ECONOMIC DEVELOPMENT AUTHORITY AGENDA

A. **Consider Revised Plans and Purchase and Development Agreement for a Data Center at
1911 Thiesse Dr.**

MEMO

RE: Consider Revised Purchase and Development Agreement with Blockmetrix

AERIAL MAP

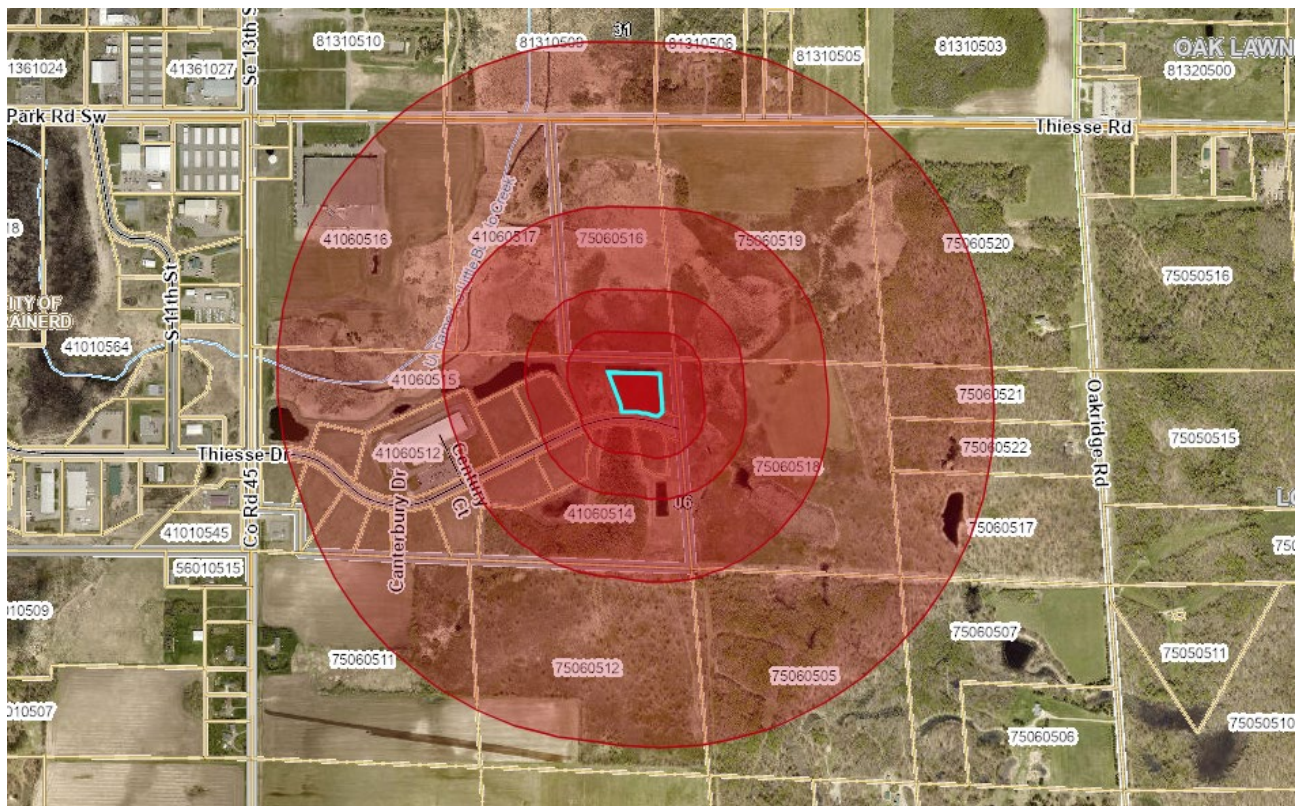
The 47 dBA at 1,056 feet does not exceed NAC 1 standards as there are no residential houses with any of the parcels at 1,056 feet.

Note: Map assumes that the coolers are located at the property line which is not the case as depicted in the site plan.
